AIA® Document G701® – 2017

Change Order

PROJECT: <i>(Name and address)</i> Renovation Central Bus Garage Complex & Glenn O. Swing Elementary Covington, KY	CONTRACT INFORMATION: Contract For: General Construction Date: 05/12/2023	CHANGE ORDER INFORMATION: Change Order Number: 002 Date: 07/18/2023
OWNER: <i>(Name and address)</i> Covington Independent Board of Education 25 East 7th Street Covington, KY 41011	ARCHITECT: <i>(Name and address)</i> PCA Architecture, PSC 906 Monmouth Street Newport, KY 41071	CONTRACTOR: <i>(Name and address)</i> Schrudde & Zimmerman, Inc. 1671 Park Road, Suite 11 Ft. Wright, KY 41011

Processed under Change Order No. 002

RFI #: 10

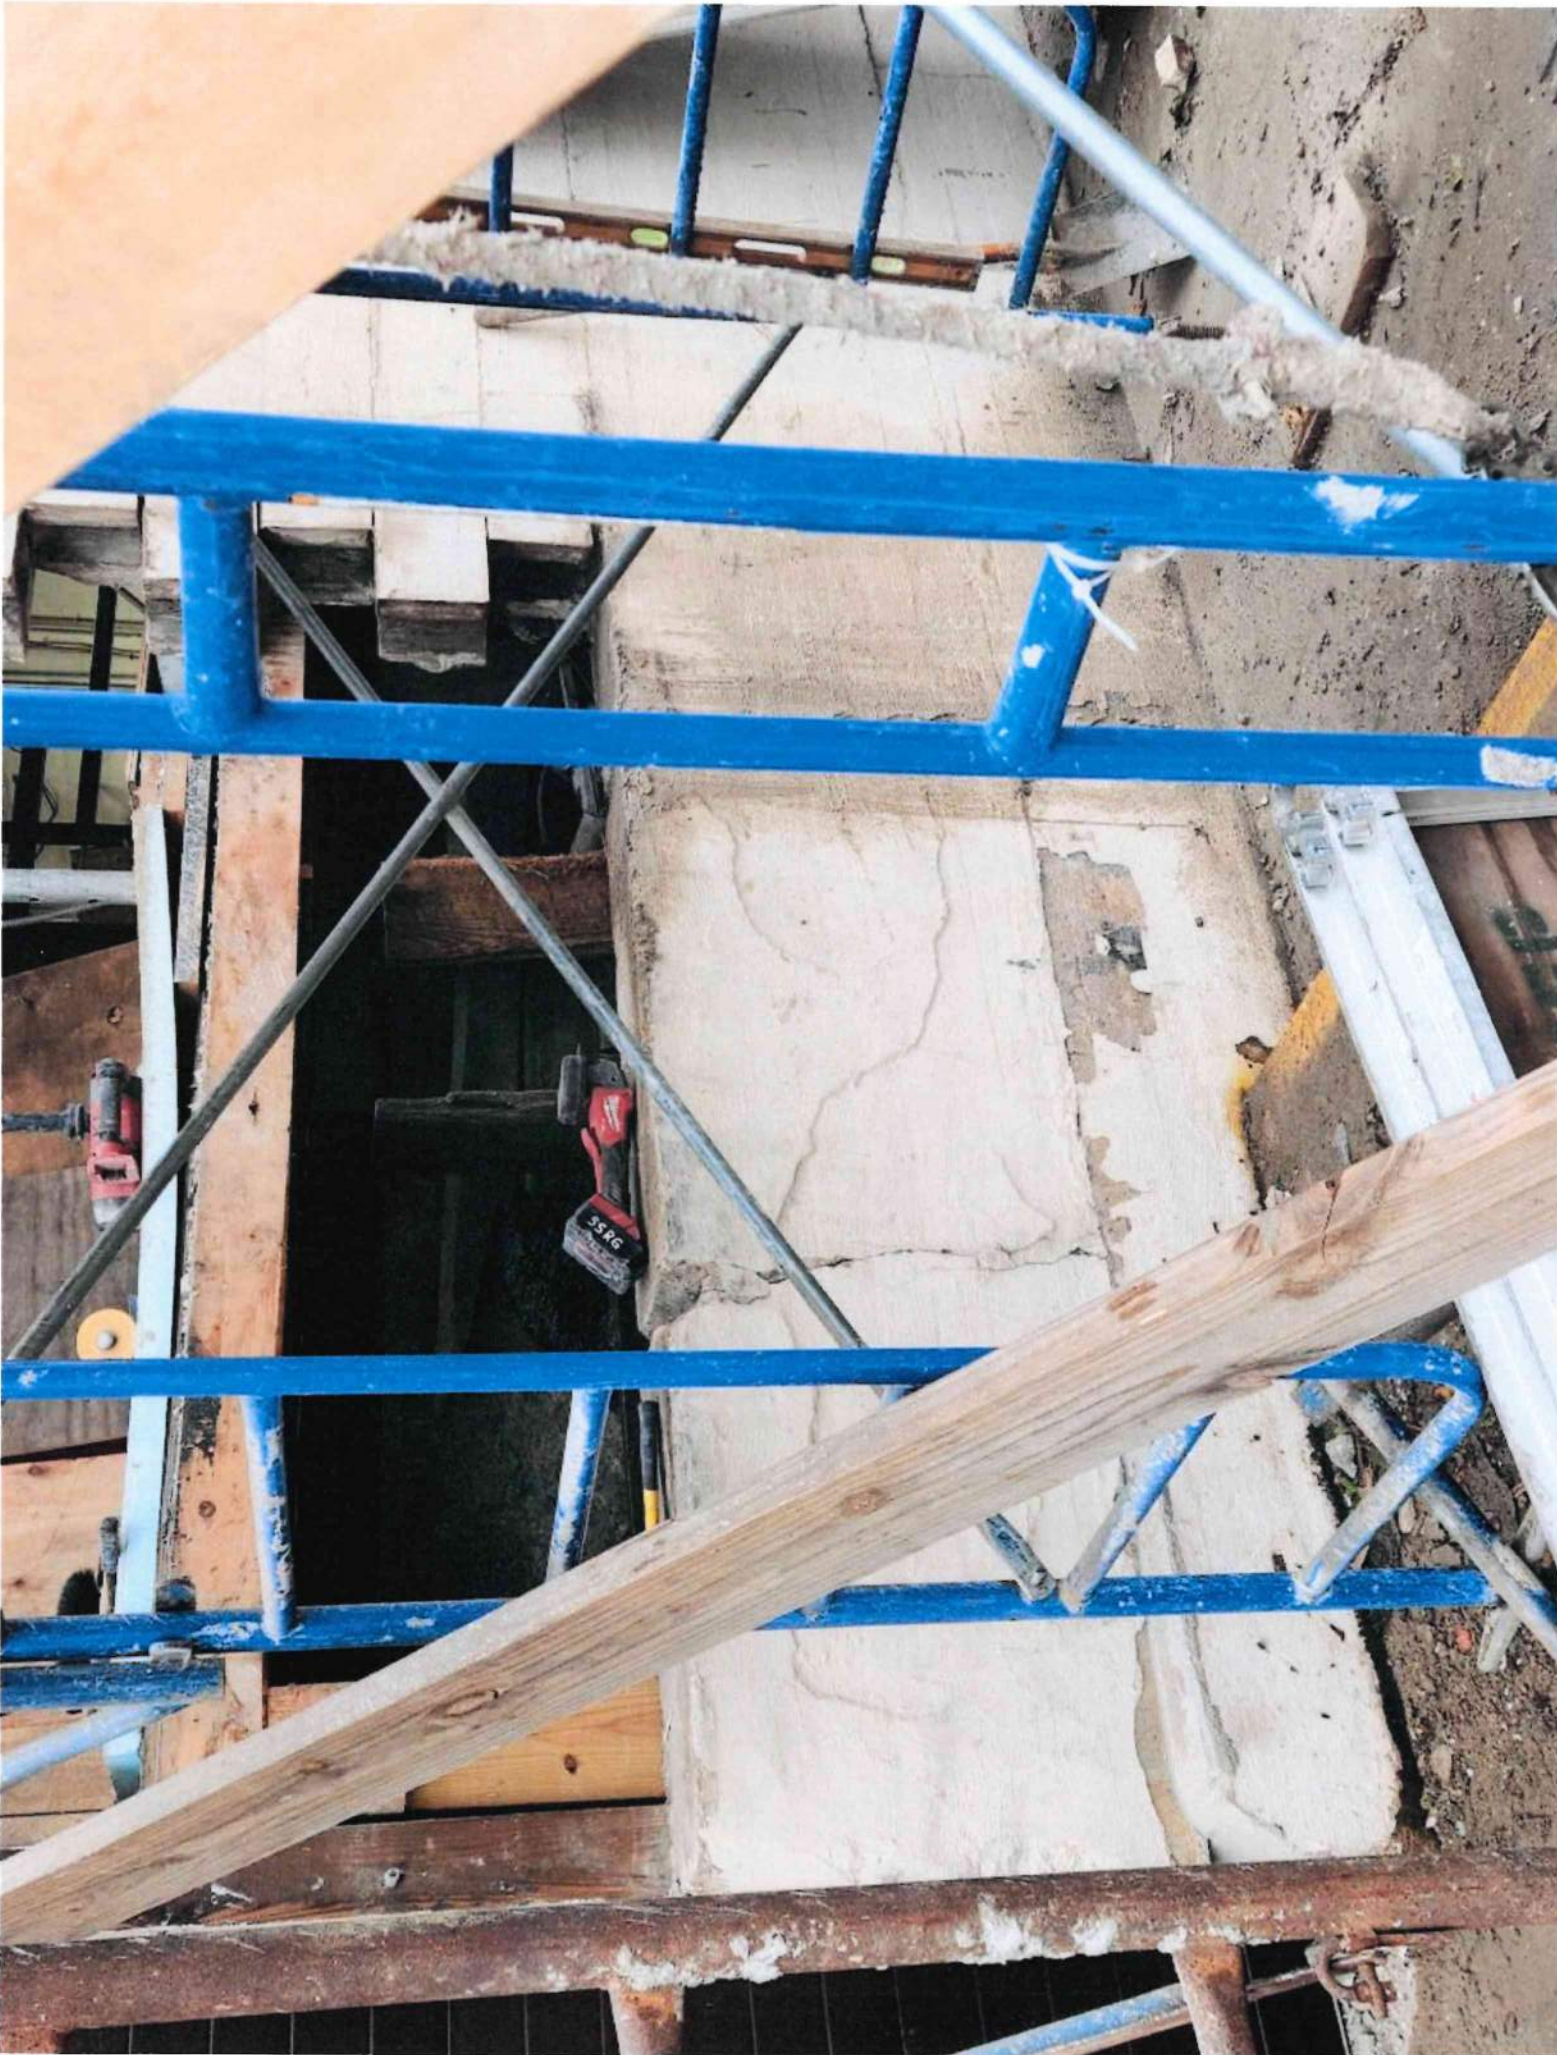
Bus Garage Foundation

The existing foundation on the rear of the building is cracked in several spots and leaning, mason is concerned about laying cmu on top of it.

Thoughts are to drill & epoxy dowels into existing and starting with a bond beam or to remove the foundation, drill & epoxy dowels, and starting with a bond beam.

RED square below shows area in question

Robin from Advantage was onsite today and reviewed the foundation. He directed us to remove the foundation down to the floor elevation and start the masonry repair at that point.

PCA agrees with the proposed changes.
